STAFF RECOMMENDATION

311 Chapel Avenue

Application: New Construction—Outbuilding/Detached Accessory Dwelling Unit

District: Eastwood Neighborhood Conservation Zoning Overlay

Figure 3: Rendering showing roof form and dormer

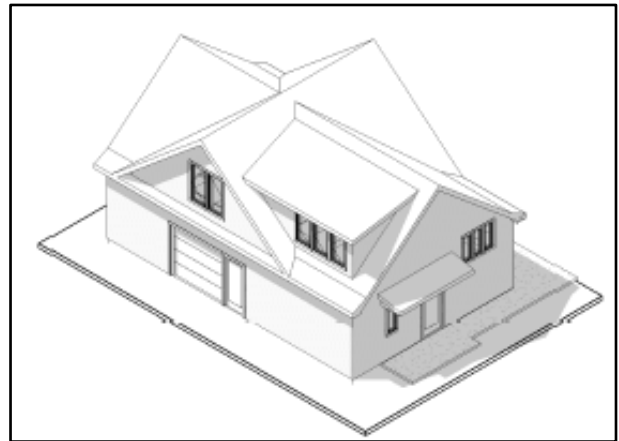
The primary roof form is cross gabled, which is appropriate. A shed dormer on the interior side elevation occupies less than fifty percent (50%) of the wall plane and is inset the required two feet (2') from the wall below Figure 3).

Staff finds that the proposal meets the Section II.B.h.1 of the design guidelines for roof form.

Figure 4: Site plan

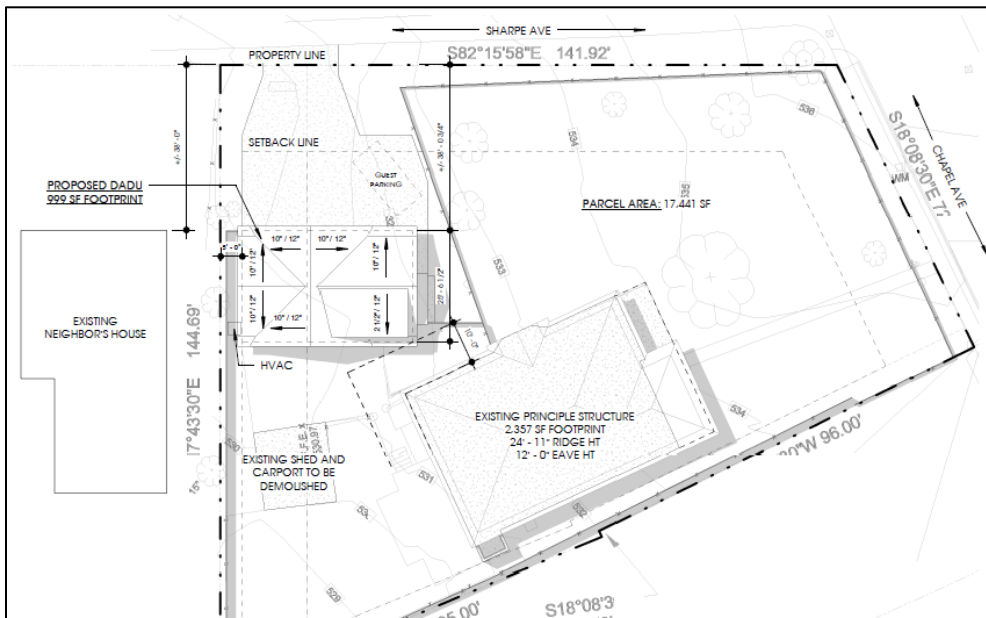
The odd shape of the lot and the deep front setback of the primary structure create a unique challenge for site planning and setbacks (Figure 4). The base zoning requires a twenty foot (20') setback from the side street when the garage doors face the street. However, the historic houses along Sharpe Avenue are setback much further, at approximately thirty-eight feet (38') from the street (Figure 5). Additionally, the guidelines require a twenty foot (20') distance between the house and DADU. Given the location of the house in relation to Sharpe, a twenty foot (20') distance would push the DADU into the setback. The applicant worked with staff to design the proposal presented here wherein the DADU's setback will align with the historic houses along Sharpe, and a ten foot (10') distance to the primary structure will be provided. The Commission has reduced this distance to ten feet (10') in previous cases where there were unusual lot restraints.

Staff finds that when viewed as a whole, these proposed setbacks are appropriate to this specific site and that the project as proposed meets Section II.B.h.2 of the guidelines for setbacks and site requirements.
